Original Report (CPC2019-1239)

Planning & Development Report to
Calgary Planning Commission
2019 October 17

Policy Amendment and Land Use Amendment in Hillhurst (Ward 7) at multiple properties, LOC2019-0058

Illustration 1: Building Height in this Direct Control District

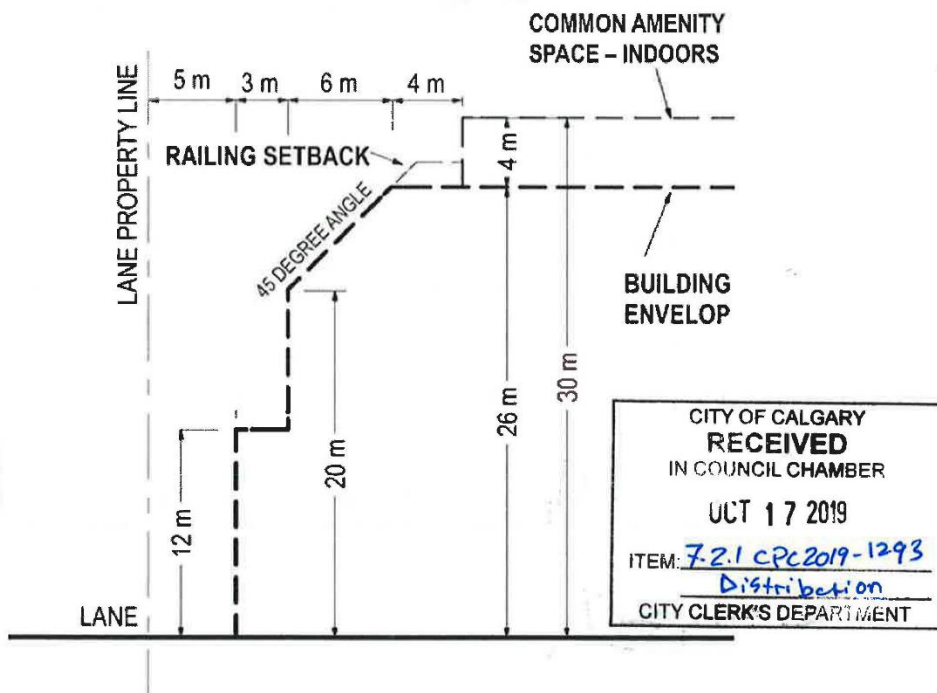
In addition, the application seeks a 30m final height above the requested 26m to provide direction on the future indoor building amenity space. We understand that the rooftop mechanical structure is exempt from overall building height calculations and appreciate efforts to finalize the final height at the outset of the application. However, we feel the additional 4m ask - essentially another floor - is beyond our comfort zone. We believe that the building amenity space should be accommodated within the final height at Council's approval.

30 Metres. The ask to allow amenity space as part of the mechanical penthouse adds people to an otherwise lifeless structure making it easier for the design of the top of building to be attractive. Given the unfortunate roofscapes on most buildings, this approach—where public amenity enhances the top (versus mechanical only—should be encouraged instead of discouraged). The proposed by-law defines the appropriate restraints needed to mitigate any potential impacts. The reality is that the size of the mechanical penthouse equipment will be much the same with or without the added public space. This requested variance of the existing mechanical penthouse rule fosters the opportunity to create a beautiful form at the top that reflects life and vitality rather than the norm of arbitrary geometric shapes created to shroud mechanical space—without increasing the real building height.
